ISC-C1 Rack

Title		
ISC System Wiring Diagram		
Size	Number	Revision
B	D1900511	V11
Date:	8/28/2024	Sheet of 1 39
File:	C:\Users\...ISC_C1_SH1.SchDoc	Drawn By: Filiberto Clara

ISC-C3 Rack

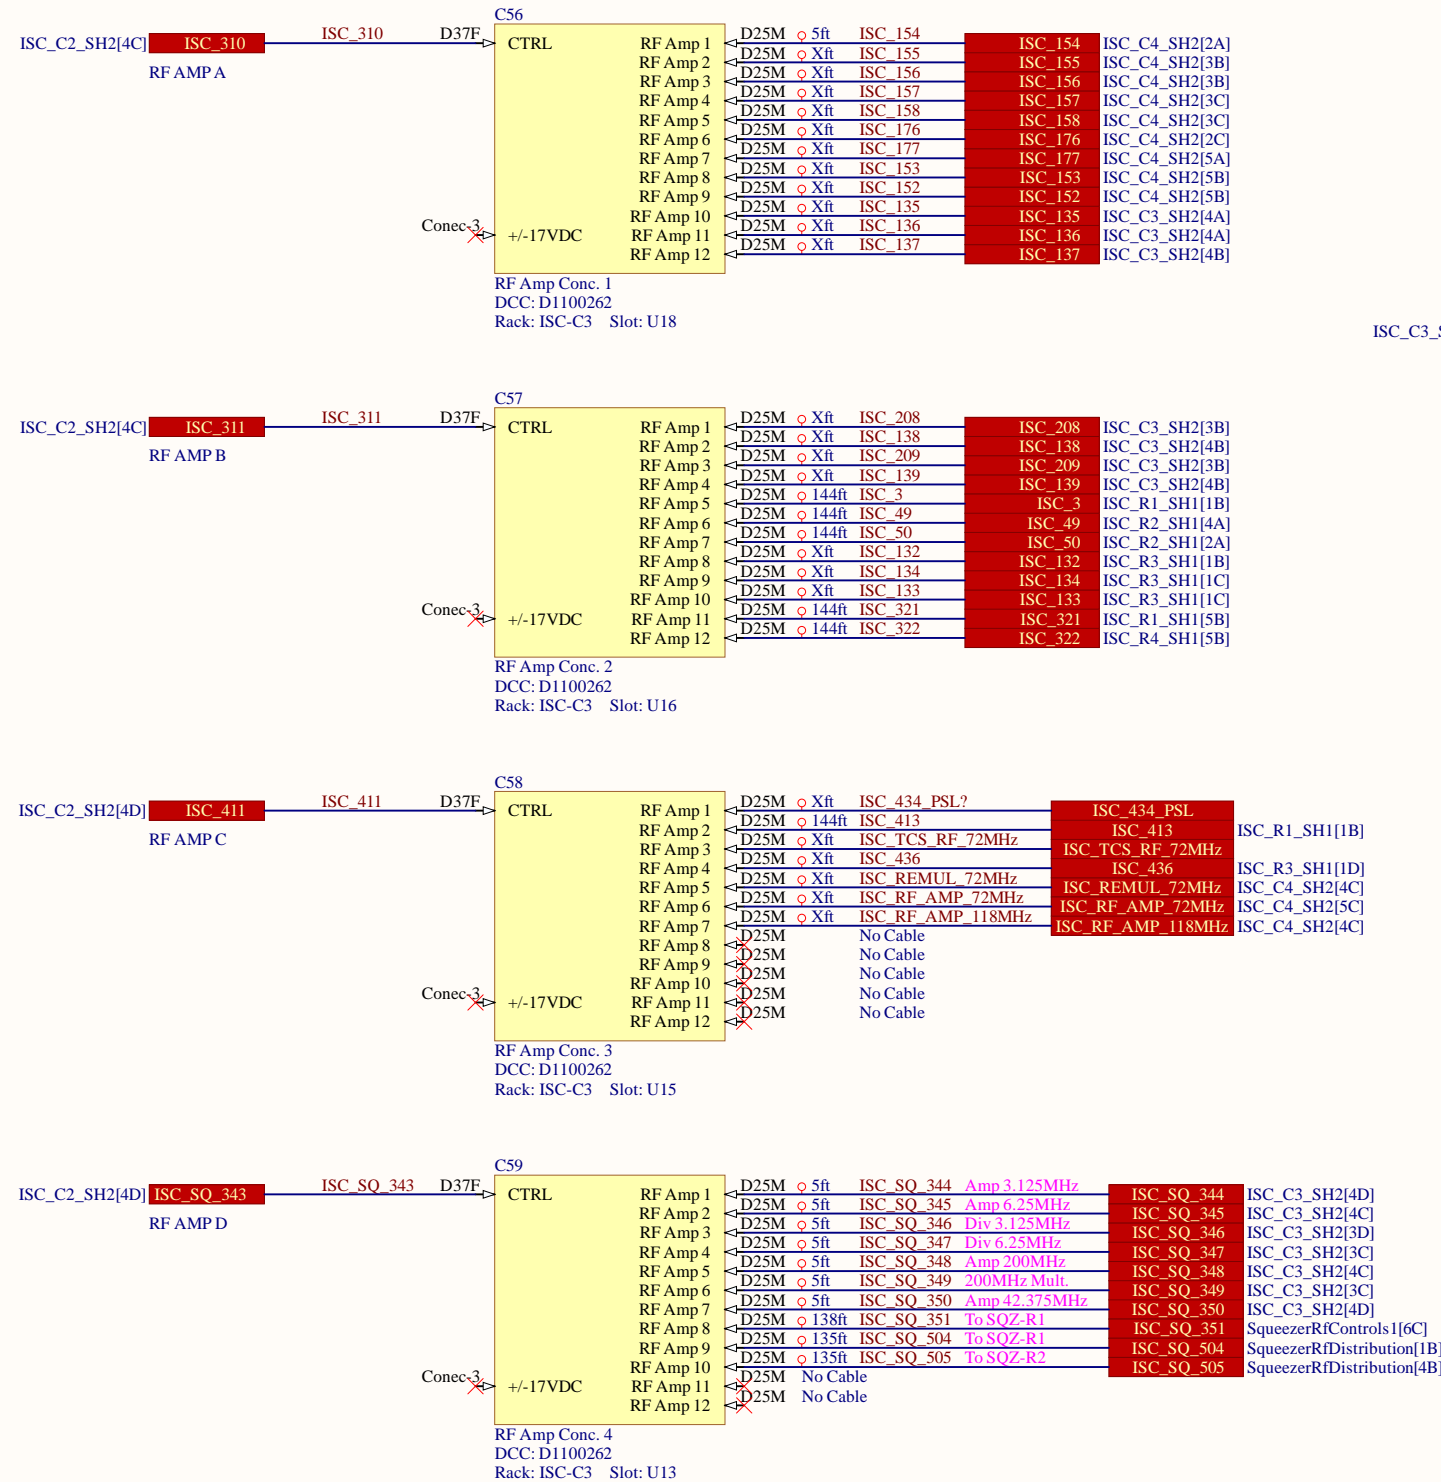
Need Locations of other ends.
 SEI IO Chassis

ISC-R1 Rack

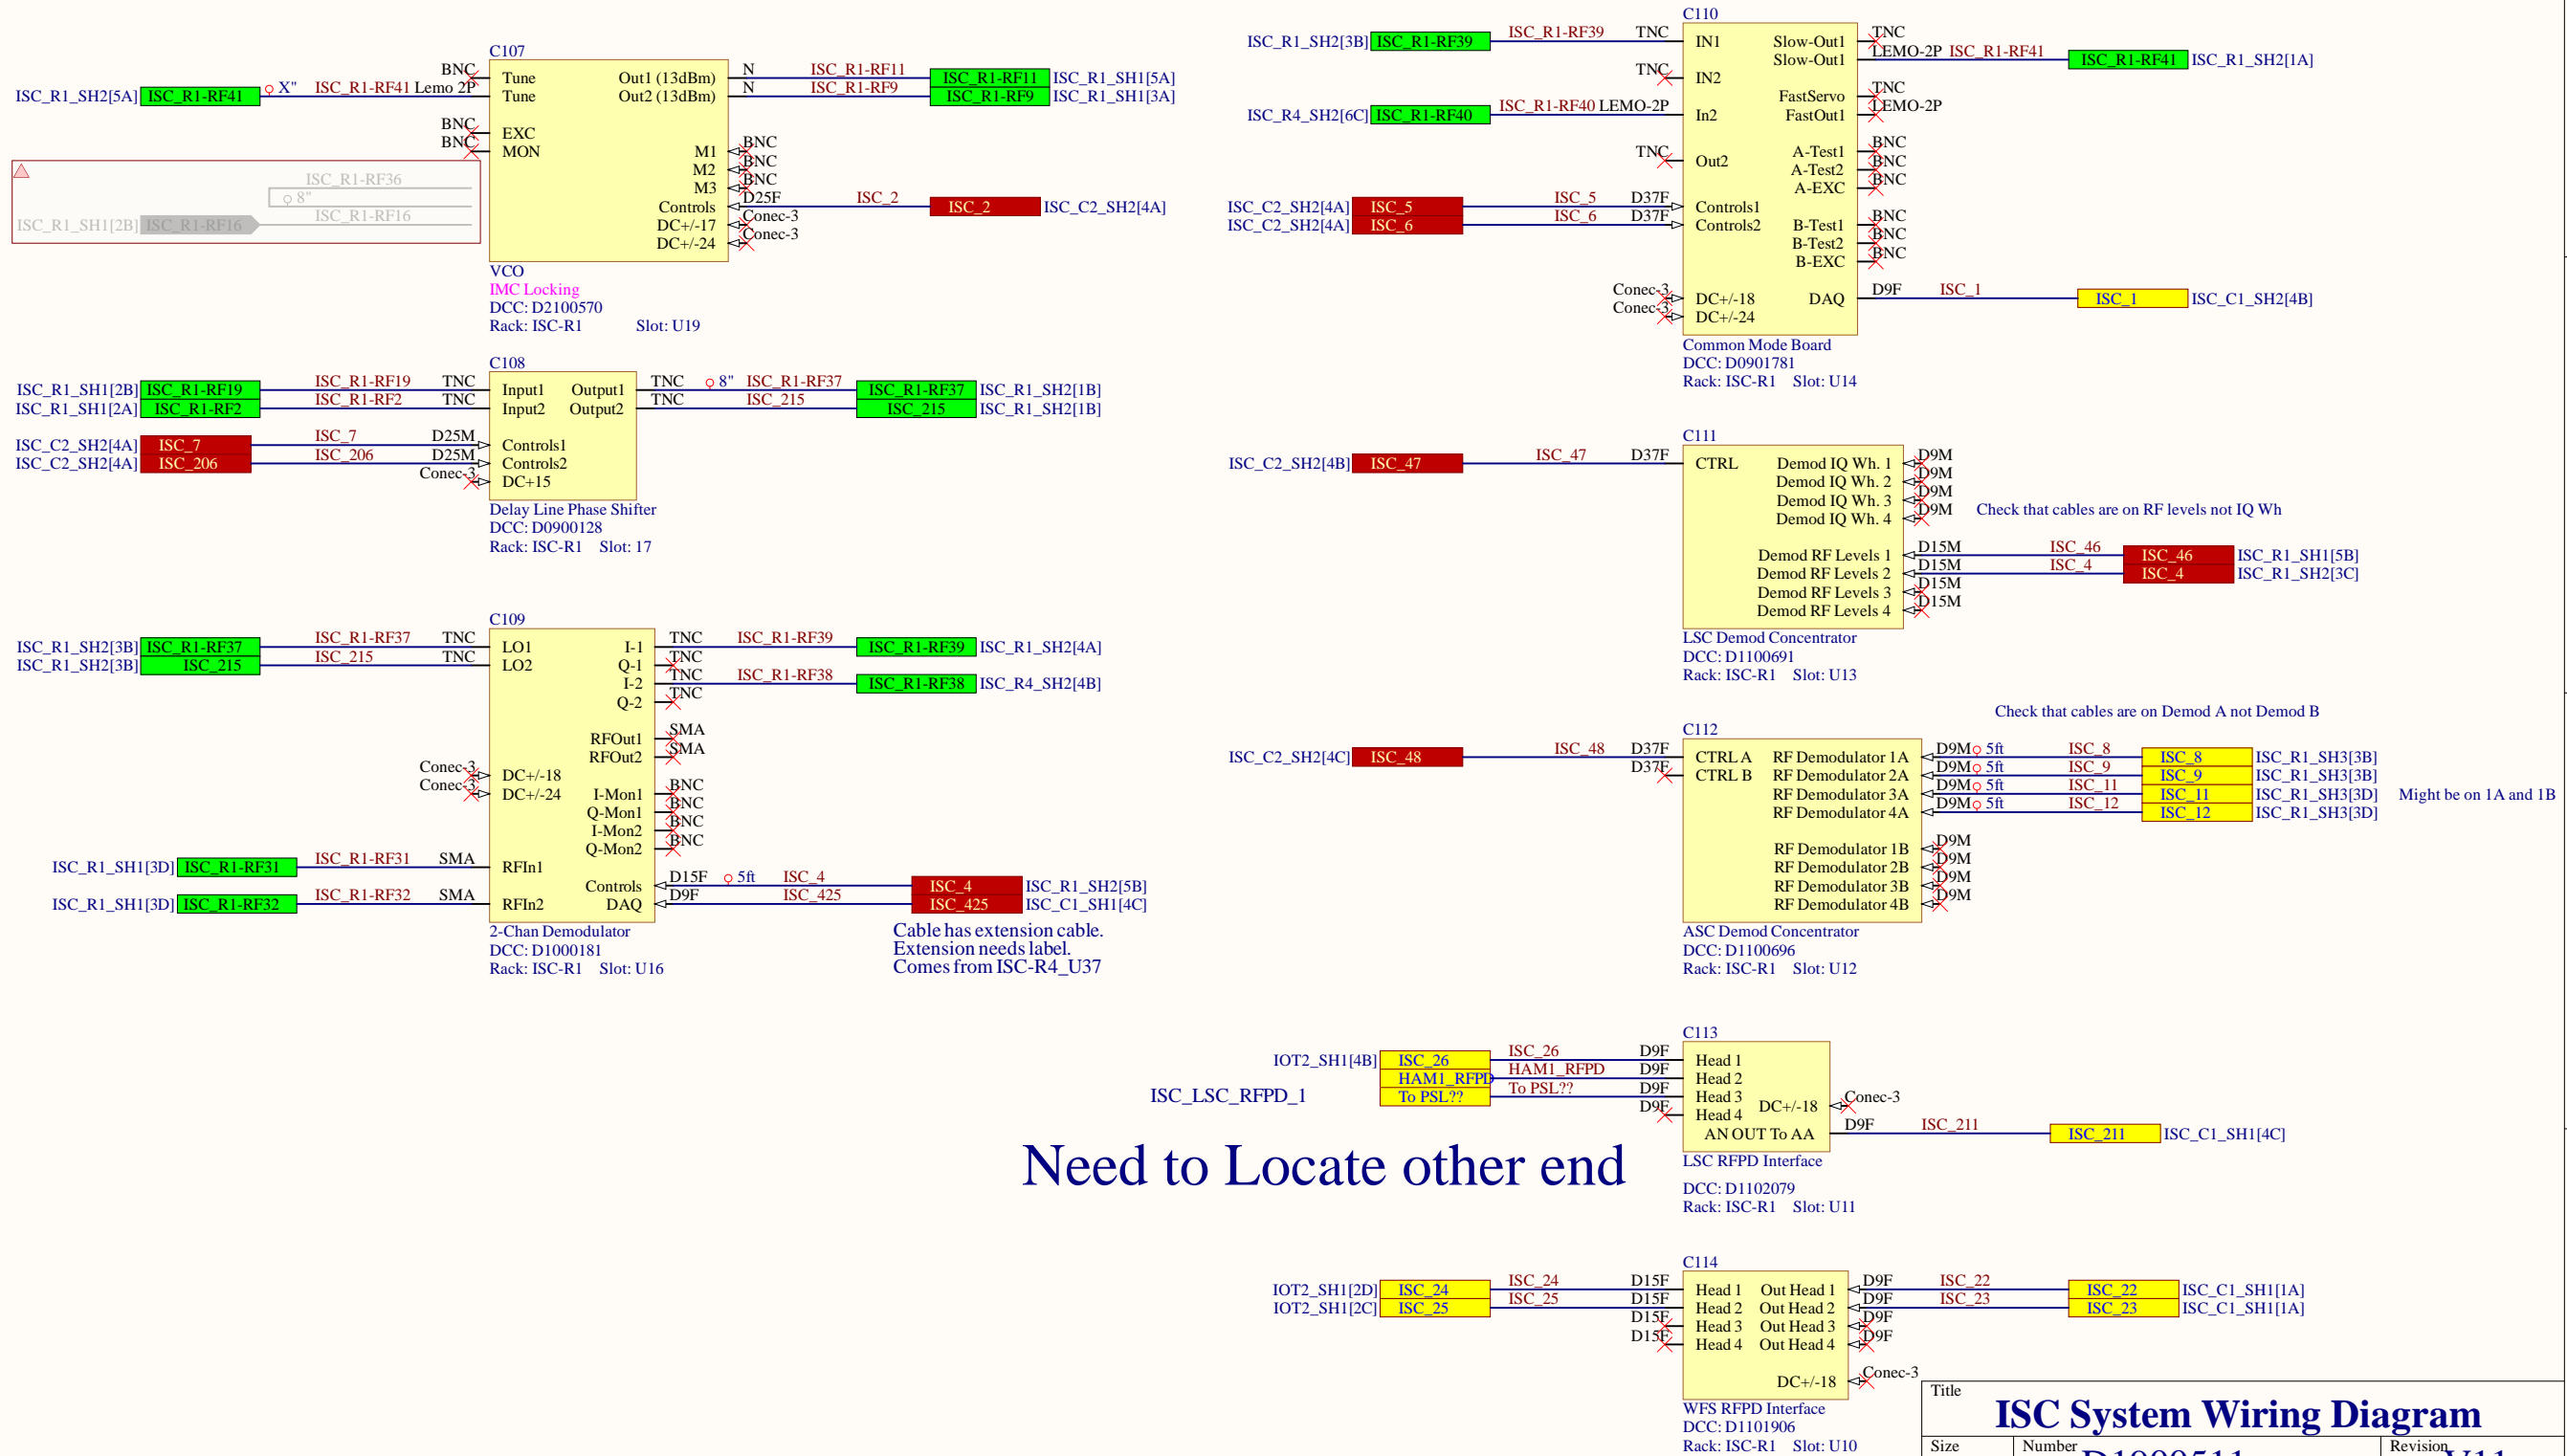
Need to Locate other end

ISC-R1 Rack

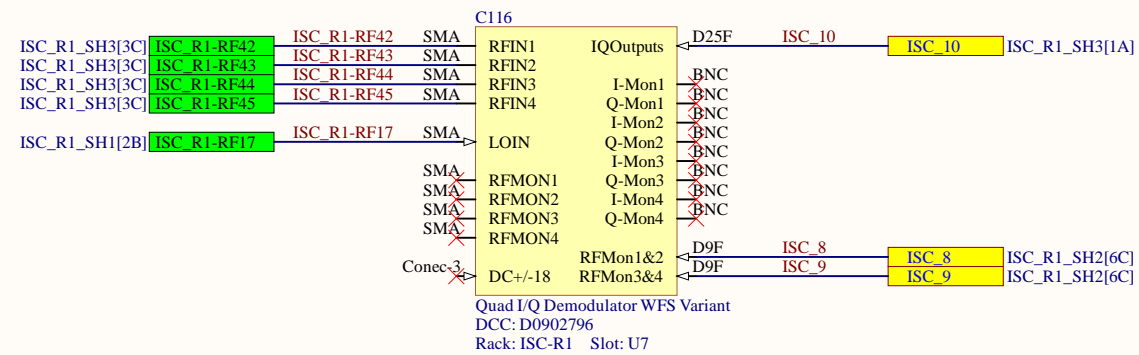
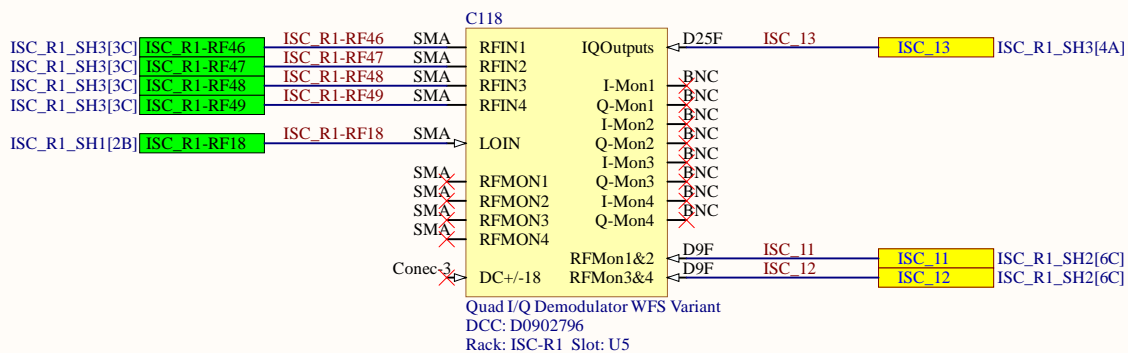
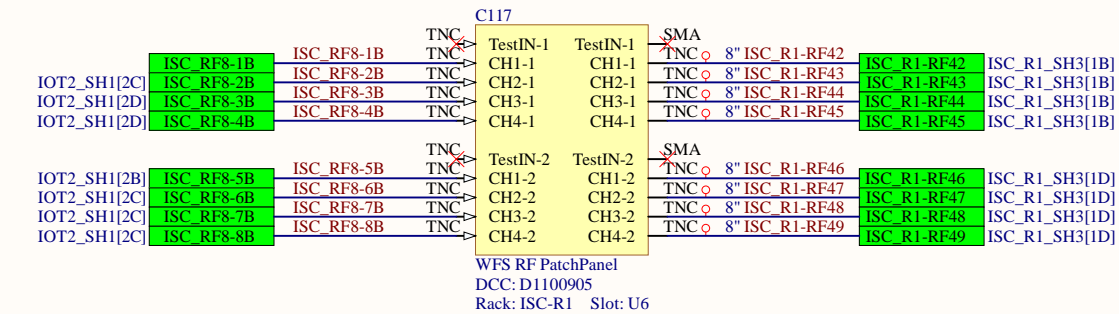
Need to locate other end

434/435 already used
 ASC-POP_X_PIT/YAW

ISC-R4 Rack

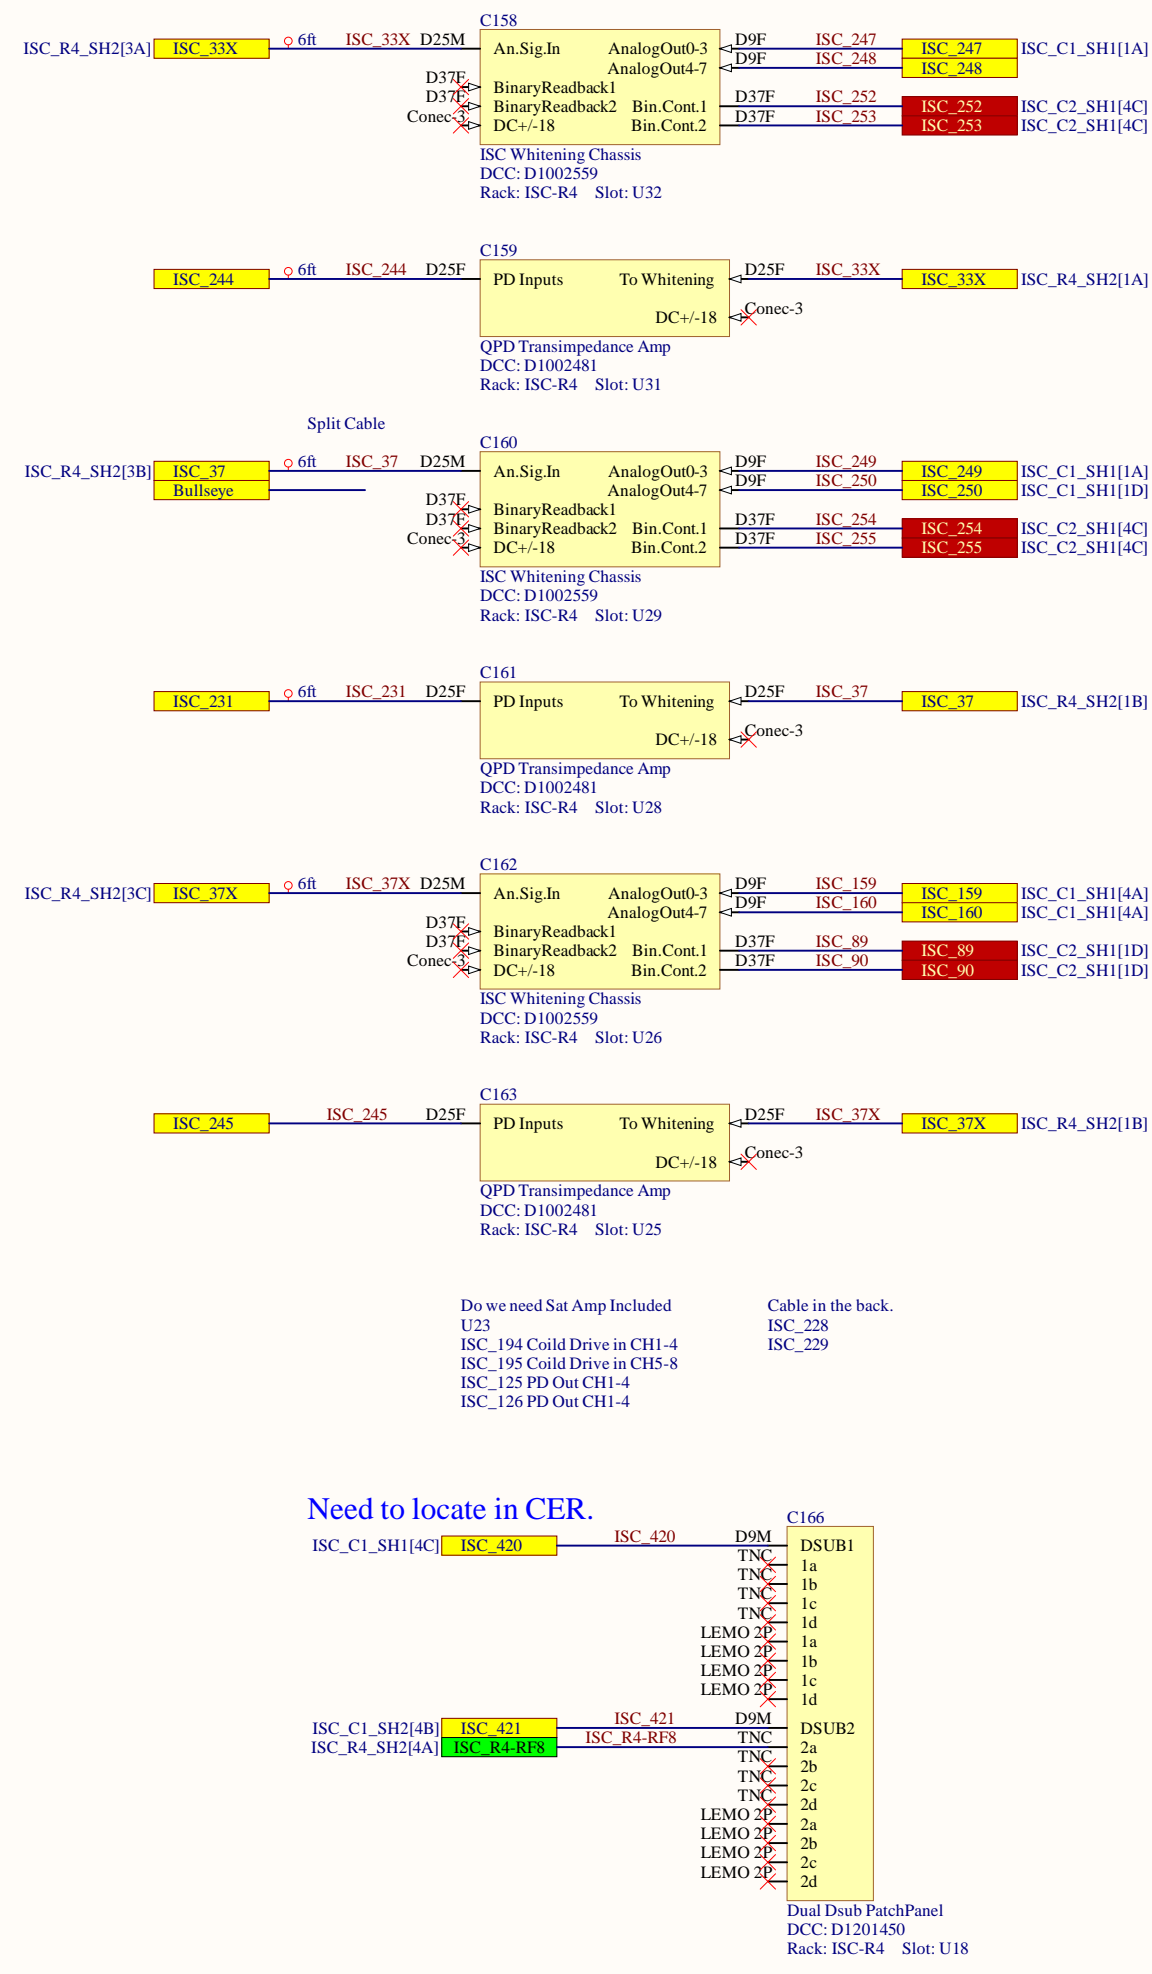
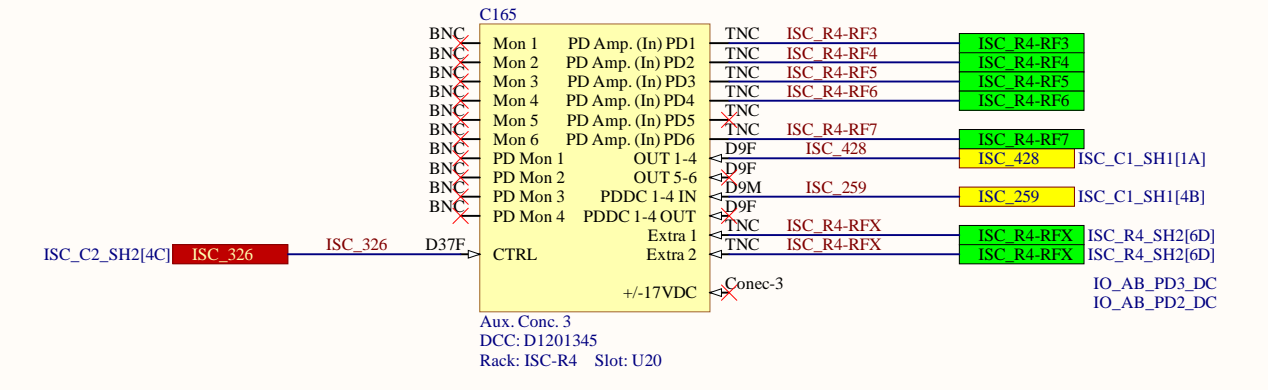
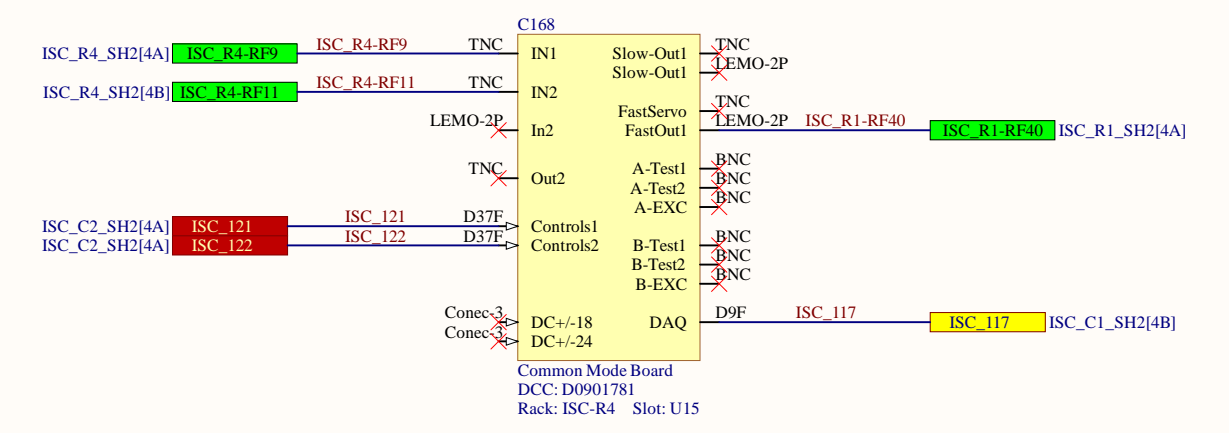
Otherside not labeled. RED
Otherside not labeled. Green
Otherside not labeled. R4 ISC1
Otherside not labeled. R4 ISC2
Otherside not labeled. Old label H1_ALS_PSL_PD1

Need to locate in CER.

Do we need Sat Amp Included
U23
ISC_194 Coild Drive in CH1-4
ISC_195 Coild Drive in CH5-8
ISC_125 PD Out CH1-4
ISC_126 PD Out CH1-4

Cable in the back.
ISC_228
ISC_229

ISC-R3 Rack

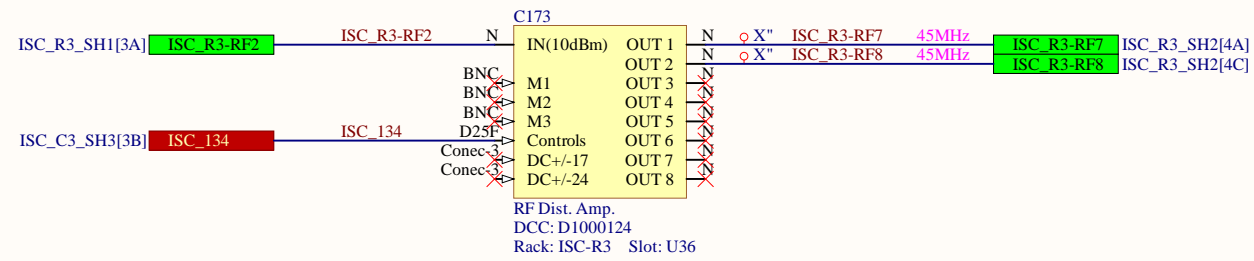
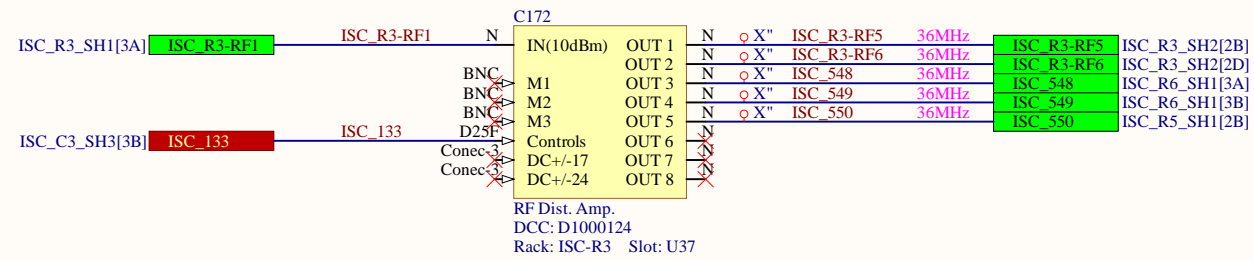
Need to Relabel ISC_R3-RF4
